# 66106A-08

## S E R V I C E N O T E

### 66106A DC Power Supply

**The instrument will not communicate or will not complete self test.**

**Figure1**

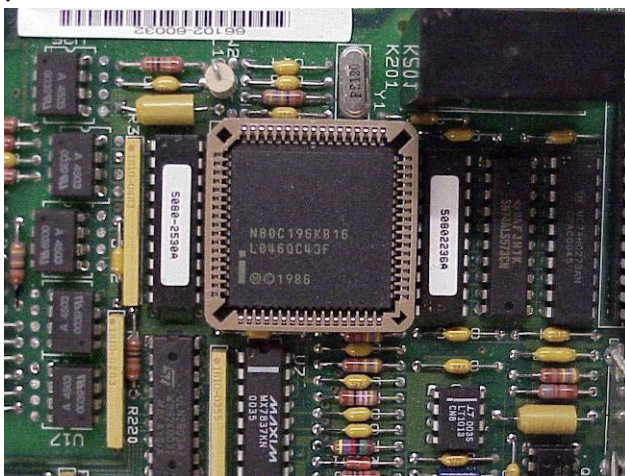
Figure 1 will help to identify the **68-PIN PLCC SOCKET location** - P/N 1200-1274 (Circuit Reference “U001”)

**Figure 2**

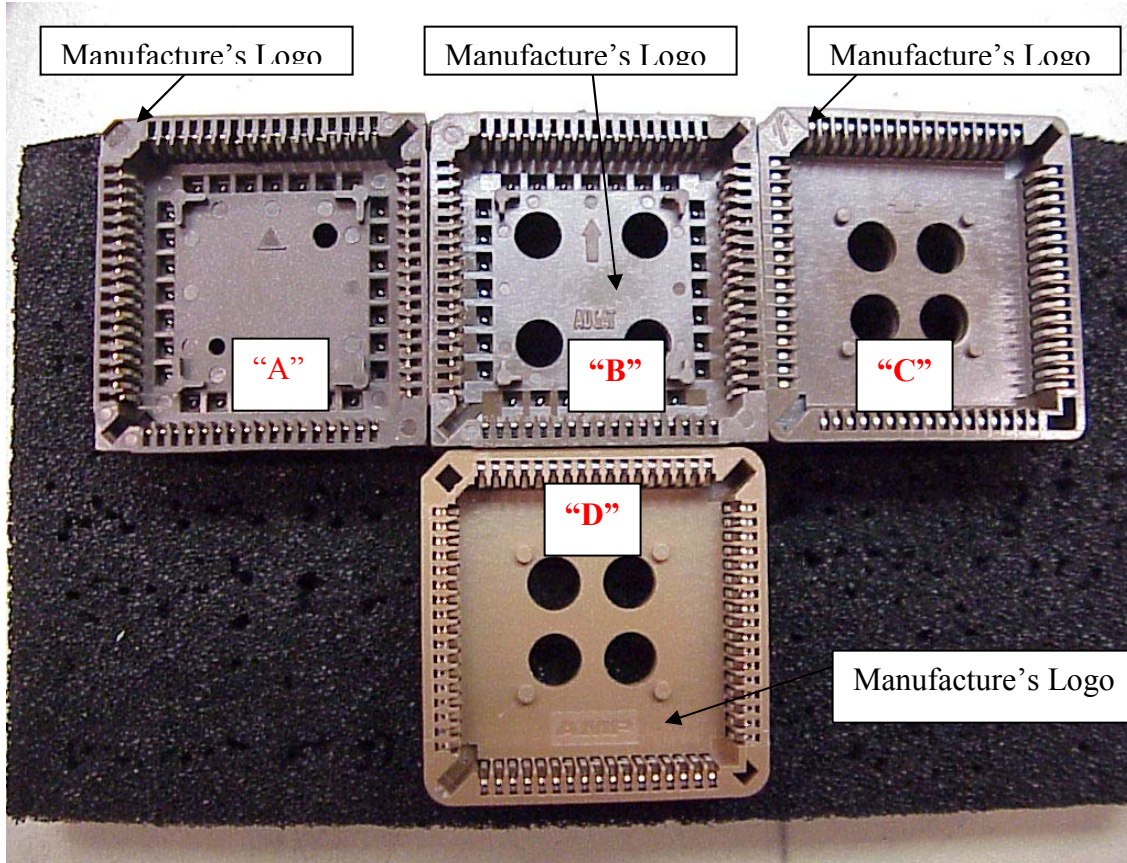
This figure should be used to identify **GOOD** sockets and a potential defective socket. The **16-Bit MCU 16 MHZ 68PLCC CMOS IC** (P/N 1821-1479) is **NOT** pictured.

The following information will help identify each socket type and manufacturer. The manufacturer's logo can be identified as shown. After the **16-Bit MCU 16 MHZ 68PLCC CMOS IC** has been removed there are also mold markings that can be easily viewed these markings should be used to identify a **Good or Defective socket**.

- Socket **"A"** is a sample of a GOOD AMP socket.
- Socket **"B"** is a sample of a GOOD Tyco/Augit socket.
- Socket **"C"** is a sample of a GOOD FCI socket.
- Socket **"D"** is a sample of a DEFECTIVE Tyco socket.

The sockets above labeled **"A", "B" or "C"** are good and should NOT be replaced.  
The socket above labeled **"D"** is considered defective should be replaced.

Any Model having a serial number starting and ending with the serial numbers shown in the chart below should have the socket 68-PIN PLCC SOCKET - P/N 1200-1274 (Circuit Reference "U001") **REPLACED!**

**Discipline A – Permanent Corrective Action Plan “The socket shown in the pictures are for reference ONLY”**

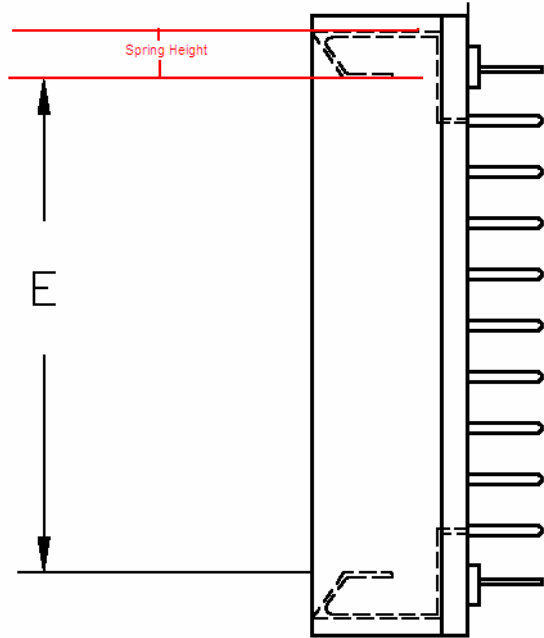
The condition of the recessed beams has been corrected by a design enhancement implemented in production. This design enhancement increased the spring height dimension by 0.04mm and decreased the spring height tolerance by 40%. The spring height dimension is shown in the drawing below.

This design enhancement is intended to position the contact beams closer to the middle of the socket and increase the normal force exerted on the contacts of the chips mated to the socket.

**Discipline B – Verification of Corrective Action “The socket shown in the pictures are for reference ONLY”**

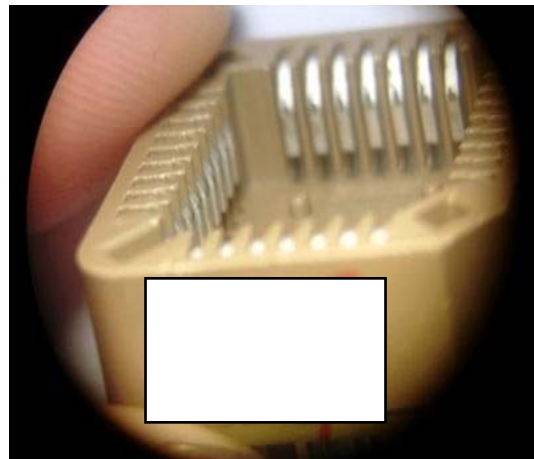
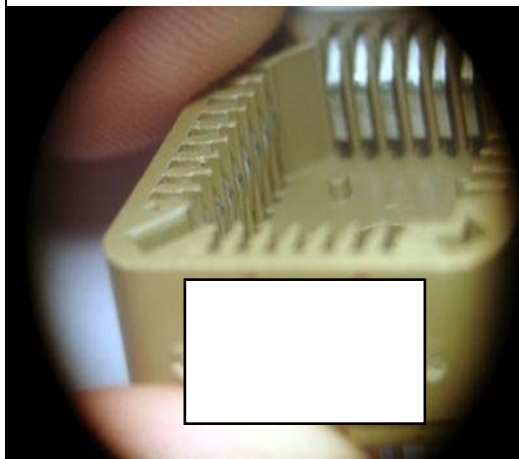
The effectiveness of this design enhancement was tested by comparing the mating and un-mating forces on the older and newer designs. The test results for sockets with the increased spring height (newer design) showed an increase in the mean mating force of 18.9% and an increase in the mean un-mating force of 23.4%. The increase in the un-mating force test results between the old design and the new design indicate that a greater normal force is being exerted on the test chip contacts by the socket contact beams. The two revisions of this contact beam design were visually examined after the mating and un-mating force testing. Photos of the two sockets are shown below. The photo on the left shows the older version socket prior to the enhanced contact beam design. The photo on the right shows a socket with the design enhancement. The contacts with the older design appear to be recessed farther into the housing after un-mating.

Material with this design enhancement will be labeled with a 2007 date code
